SUBJECT: SURVEY OF V. C. SUMMER CONTROL ROOM

NRR FINDINGS V. C. SUMMER CONTROL ROOM

PLANT VISIT SUMMARY

Figure 1 V.C. Summer Test 11 F.

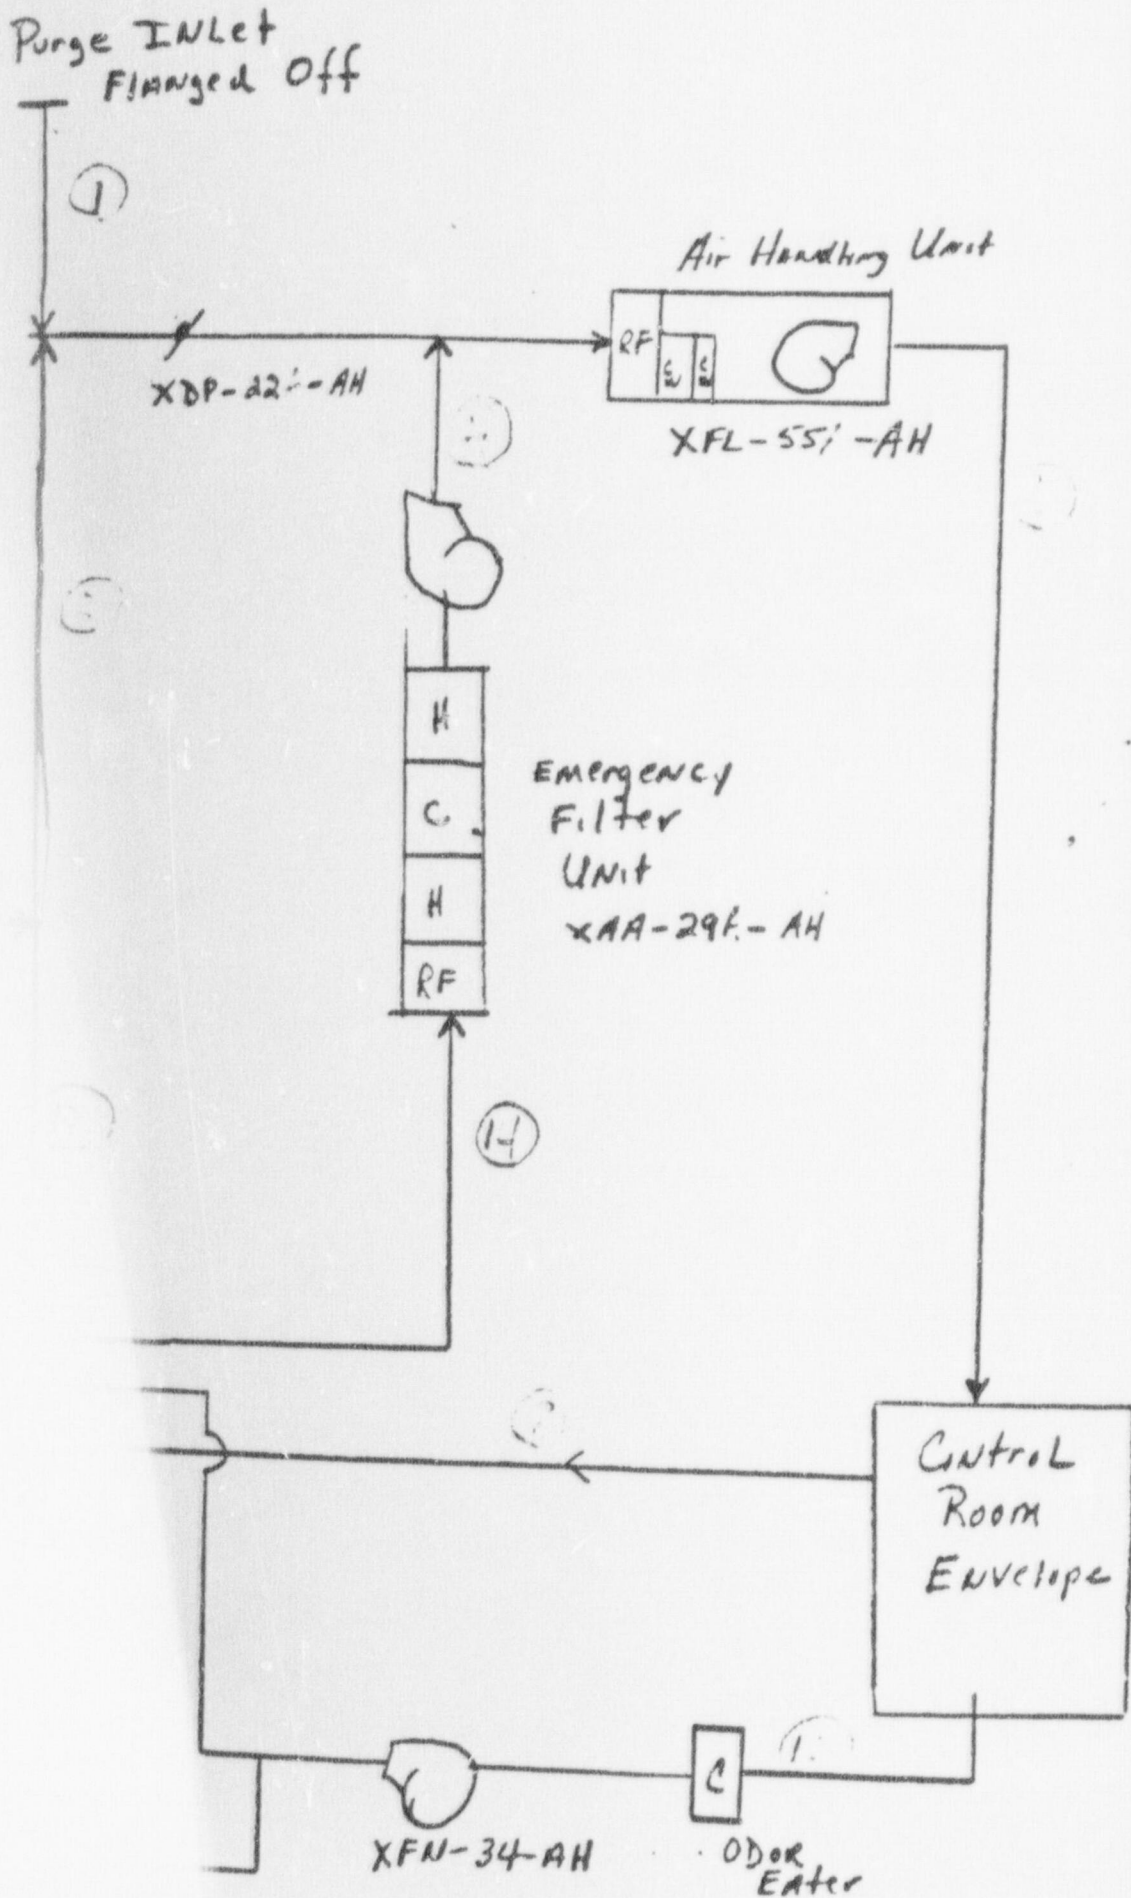
- (1) There appears to be a considerable amount of inleakage into the air handling unit. It ranged from 363-1246 cfm. This inleakage is unfiltered.
- (2) There appears to be a considerable amount of inleakage between the locations where flows at measurement points 8, 10, and 12 are made and the location where flow at measurement point 14 is made. This inleakage ranged from 1050-1620 cfm.

- (3) Only outleakage occurs across the emergency filter train. This outleakage ranges from 740-800 cfm.
- (4) The control room exhaust (return air) is greater than control room supply which would seem to indicate that the control room has another source, not measured by the survey team, which is pressurizing the envelope. The source is unknown but the deficiency between the two flows is 785-2550 cfm for the two data sets.

- (5) Filter flow is 17-19% greater than the technical specification value.
- (6) With the toilet and kitchen fan removed from the ductwork and the ductwork blanked off, the amount of flow supplied to the control room increased by 2.22% while the amount of return flow decreased by 2.78%.

With Train A idle, a flow balance around the idle air handling unit seems to indicate that there is outleakage from the air handling unit. This situation is confirmed by the fact that inleakage occurs when the train is operating. Similar confirmation occurs with respect to the outleakage in the ductwork between measurement point 14 and the locations where measurements 8, 10, and 12 are made.

The flow direction through measurement point location 2 is particularly baffling. During emergency operation, flow through the outside air intake almost equals, the flow through measurement point 12. Differences range from 1.7-9.4%. If the point 12 flow rate is added to the flow rates measured at location 2, 600-700 cfm of flow cannot be accounted for. The flow direction was determined, and it was toward the emergency filter train when the train was operating. If the train was not operating, the flow appeared to be toward the air handling unit and damper XDP-22A-AH. One scenario which may explain the situation, with the train idle, is described as follows. Back pressure from the control room causes flow toward the air handling unit (364 cfm for data set 1). Some of this flow leaks out from the air handling unit. That flow which remains (unknown) is combined with the flow from point 2 to pass through the fan and the emergency filter unit. Approximately 130 cfm leaks out from the emergency filter train. The flow from the emergency filter unit combines with the flow from the control room return duct (point 8). This gives the combined flow at point 12, which is proceeding toward the air handling unit. A portion of the flow, 148 cfm at point 2, is probably directed towards the flanged intake while the remainder is directed towards either the air handling unit or the emergency filter fan.

When the train is operating in its emergency mode of operation, since the outside air intake flow is almost equal to the flow at point 12, which is the makeup flow to the filter unit, one might conclude that the flow at point 2 seems to be recirculated by the emergency filter train back to point 2 where most of the flow is lost. Point 2 almost seems like a black hole. Flow seems to get lost here.

Figure 2 V.C Summer Train 13

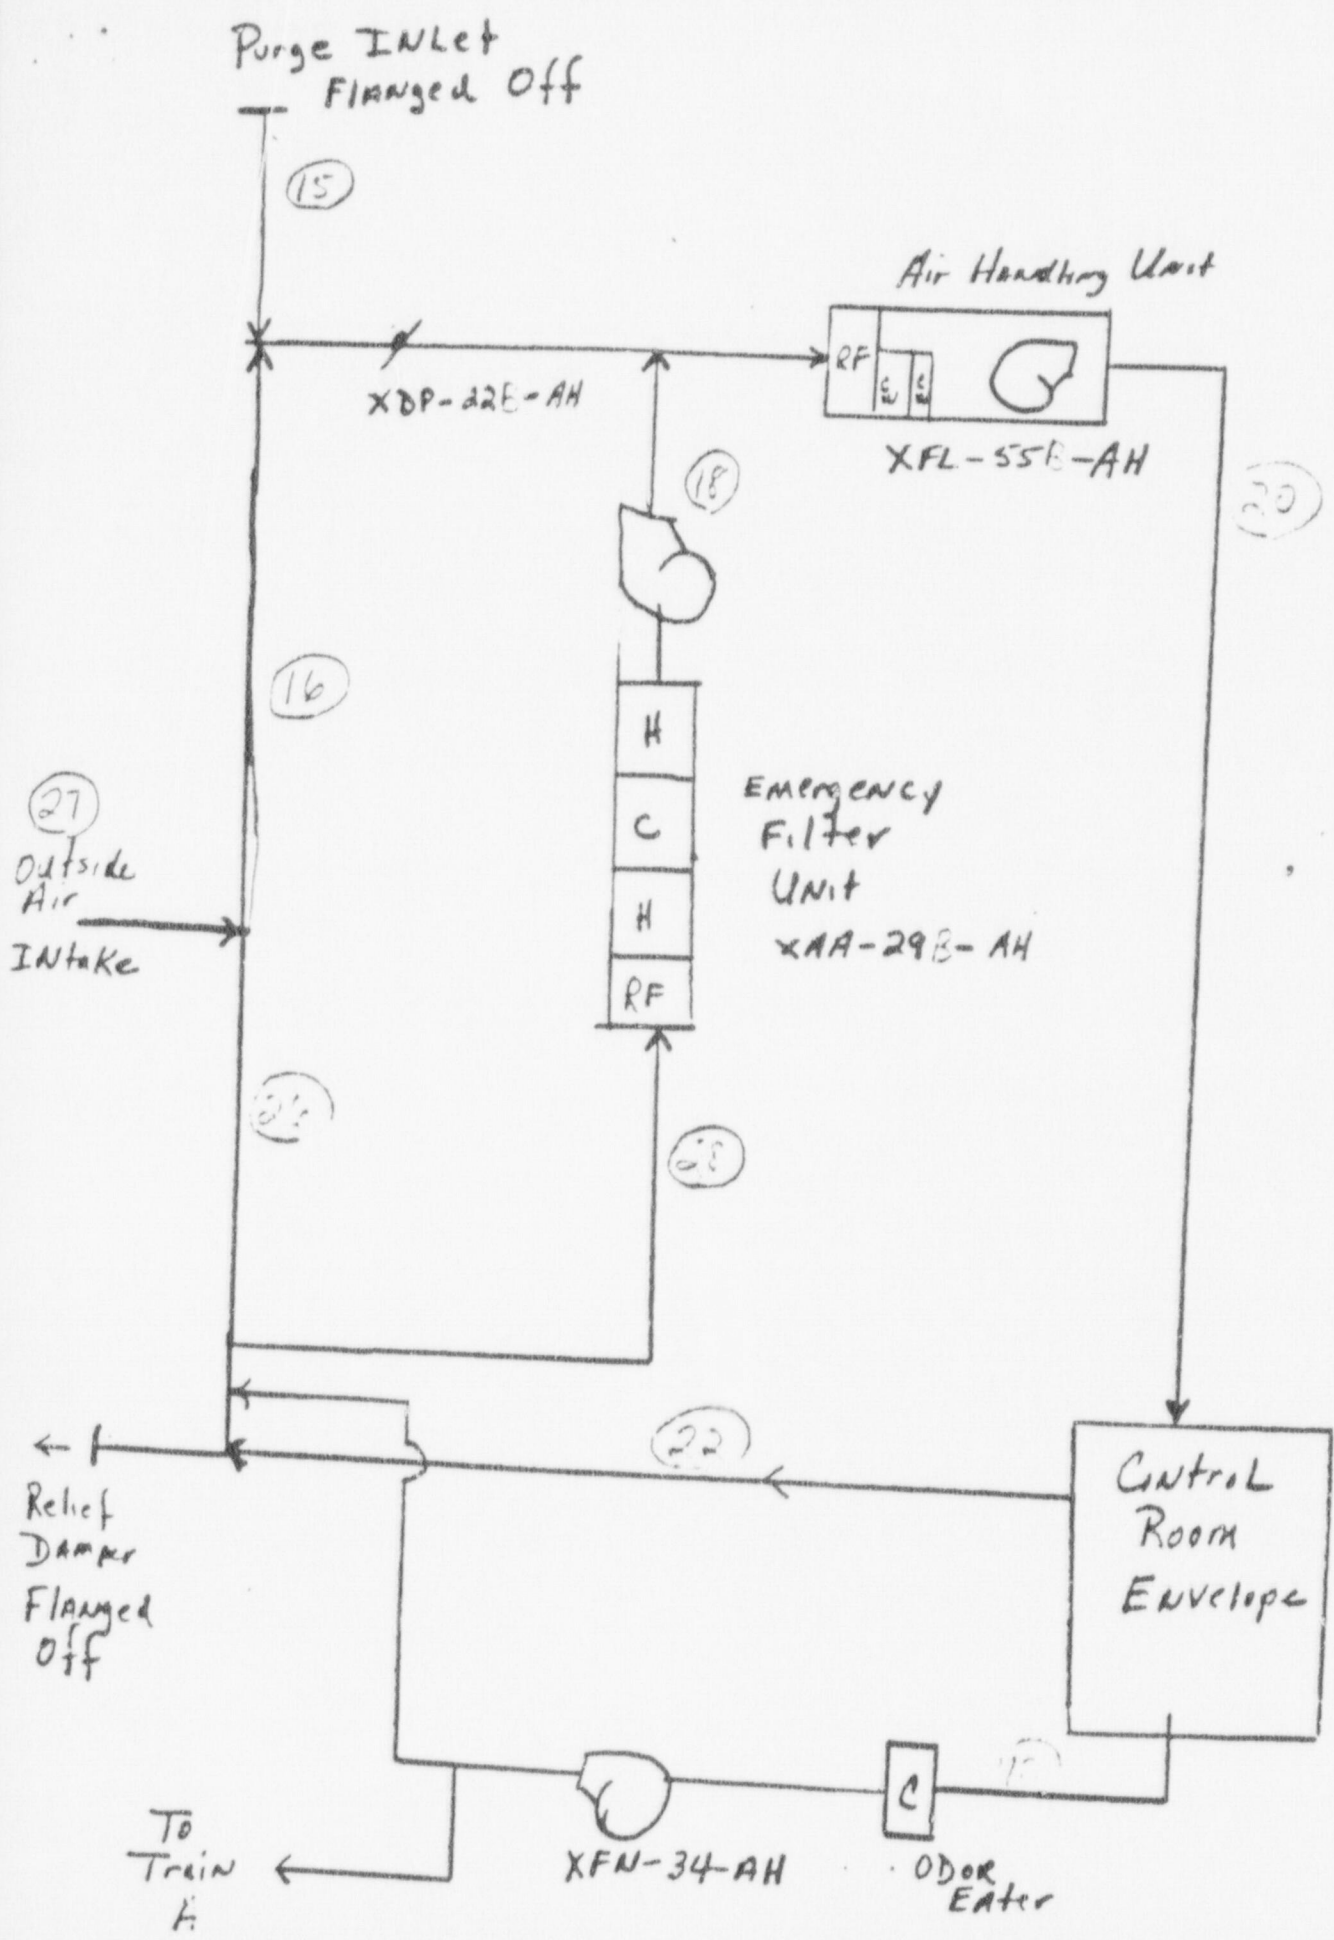
- (1) Outleakage from the air handling unit ranged from 450-680 cfm. This was the opposite of train A where inleakage occurred.
- (2) Outleakage occurred across the emergency filter unit. This ranged from 2800-3700 cfm.

- (3) As with train A, there was a considerable amount of inleakage in the ductwork between measurement points 22 and 26 and that at point 28. Amounts varied from 3250-4080 cfm.

- (4) Control room supply flow was greater than control room exhaust (return) flow in one of the two cases. Supply and exhaust flows were almost equal with a difference of only 90-100 cfm in the two cases.

- (5) Flow through the emergency filter train was 13-16% greater than the technical specification value.
- (6) When the toilet and kitchen exhaust fan was removed from the ductwork, the amount of flow to the envelope decreased and the amount of return air from the envelope increased. With the ductwork blanked off, envelope supply flow was less than envelope return flow.

For train B measurement location 16 was similar to measurement point 2 on train A. As with train A, location 16 provided abnormal flow results when considered with measurement points 15, 18 and 20.
